Planning Scheme Amendment C244melt
 Melton East Precinct Structure Plan

Tract acts on behalf of our client Mt Cottrell Land Pty Ltd (Growland) in relation this matter.

Our client provides this submission to Melton Planning Scheme Amendment C244melt (the Amendment) which seeks to, amongst other matters, rezone land for residential purposes and incorporate the draft *Melton East Precinct Structure Plan* (the PSP) and draft *Melton East Infrastructure Contributions Plan* (the ICP) into the *Melton Planning Scheme*.

Figure 1 - Extract from the exhibited Melton East PSP (Plan 3 - Housing) with Growland properties highlighted

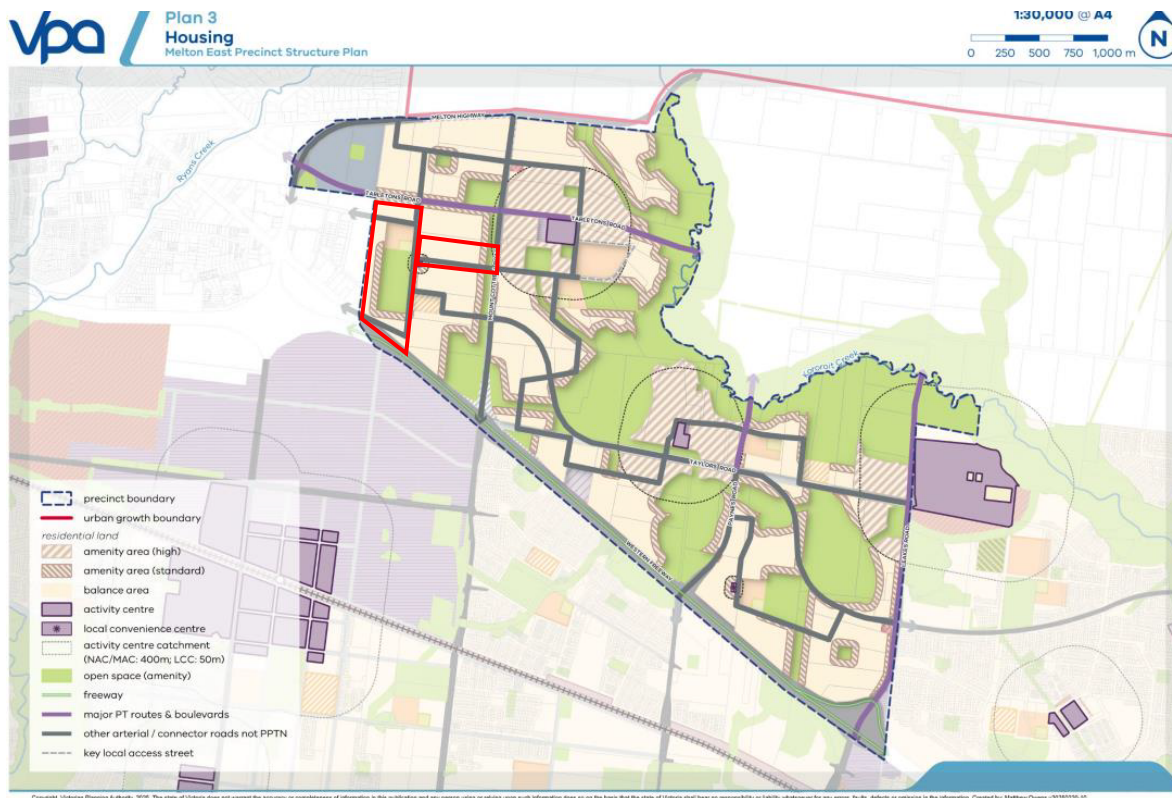
The exhibited PSP identifies a large area within 2 High Street Melton for active open space and applies a 50-metre 'amenity area (standard)' designation around the reserve where a minimum density of 30 dwellings per hectare is required in accordance with Table 3 and Plan 3. Assuming an access road encircles the reserve, the amenity area (standard) zone can accommodate a single lot depth of higher density dwellings (likely townhouses).

Several other requirements and guidelines within the exhibited PSP conflict with the ability to deliver higher density, particularly within the 50-metre standard amenity area.

Whilst we understand the objective of this requirement is to reduce driveway crossovers and promote street tree planting, the way in which this requirement is worded restricts density overall by requiring a greater proportion of road network. This reduces the land available for housing.

To achieve the minimum density of 30 dwellings per hectare NDA within the 'amenity area (standard)' precincts, a range of lot widths including 4.5-metres, 6-metres, 8.5-metres and 9.2-metres will generally be utilised, with a larger proportion of narrower lot widths. Restricting these to rear-loaded only will have unintended consequences, increasing hardscape, increasing Urban Heat Island Effect, and reducing developable area.

For the reasons above, we seek that Requirement 4 be deleted.

Figure 2 - Extract from PSP 2.0 Guidelines (VPA 2021)

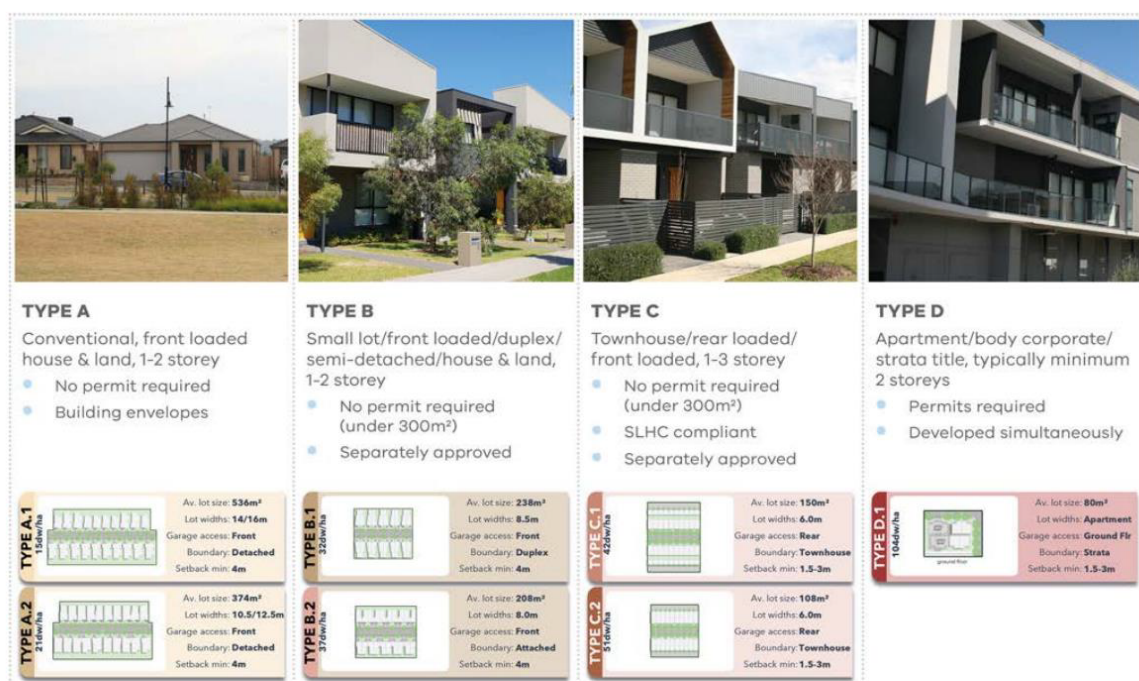
We also note the VPA's PSP 2.0 Guidelines include example typologies for Small Lot Housing Code (SLHC) Type B1 and B2 dwellings at widths of 8.5-metres and 8-metres respectively, both front loaded.

This Guideline fails to recognise that the application of 'amenity areas (standard)' as a 50-metre linear area means it is likely that only attached townhouse-style typologies are achievable at a single lot depth. Due to the spatial arrangement of these areas, it is not possible to rely on other typologies within the same 'amenity area'.

The requirement for a mix of housing typologies within the 'amenity area (standard)' should be deleted.

Figure 7 - Staging Plan (VPA, 2025) with Growland sites highlighted red, and the sub-precinct highlighted yellow.

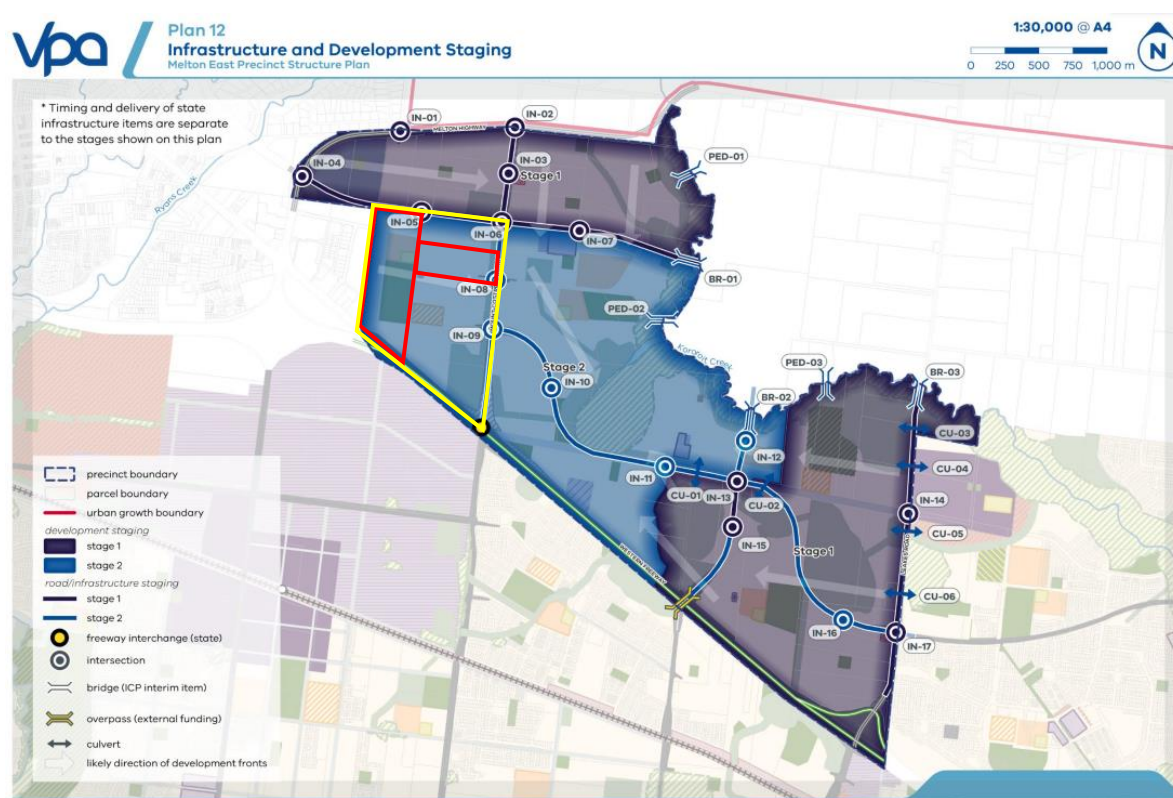
The exhibited PSP includes a Staging Plan which divides the precinct into three areas: two precincts (purple) to proceed first, and a large central precinct (blue) to proceed last (refer Figure 7).

A significant number of intersections, road network, bridges, culverts and State transport infrastructure are nominated within each stage. The Staging plan does not mention sewer, water, drainage, electricity or telecommunications infrastructure which are all necessary for the orderly development of land.

Whilst we are yet to interrogate the modelling prepared by AECOM in detail, we question the need for a staging plan which:

- Appears to exclusively consider the impact of ICP-funded transport infrastructure in the sequential development of land.
- Holds back the development of pedestrian bridges even where development adjacent may have already occurred (for example PED-01 and PED-03).

- Identifies Tarletons Road within Stage 1 (north) but does not consider the opportunity for development south of this key arterial.
- Proposes the northern portion of Stage 1 proceed without the provision of a school, sports oval, community facility, or local convenience centre.

Growland commissioned Arcadis to complete an Engineering Services Report for 2 High Street, Melton which has found the land bound south-west of Tarletons Road and Mt Cottrell Road capable of being predominantly serviced (electricity, water, telecommunications) via High Street which adjoins the site in the south-west.

Furthermore, there is a logical location in the south-east of that precinct for a temporary sewer pump station capable of servicing the entire sub-precinct.

Drainage of the sub-precinct is subject to the final design of RB-05 (also known as WLRB 4) which is located across the High Street Melton DS and the Koroit Creek Upper DS. However, it is understood that this drainage asset would largely provide for the drainage needs of the sub-precinct, or otherwise temporary drainage infrastructure could be negotiated to release the land which would otherwise be needlessly withheld from development.

The sub-precinct's existing connections into the established Melton East industrial precinct via High Street and Navigation Drive, and the precinct's potential to deliver much needed community infrastructure (government primary school, community facility, local convenience centre, and active open space reserve) to Stage 1 residents, mean it is a logical choice for inclusion within Stage 1 of the PSP.

Growland's primary position is that there should be no staging within the PSP.

It is Growland's further submission that if the Staging Plan is to remain within the PSP, land within the identified sub-precinct should be included within Stage 1.
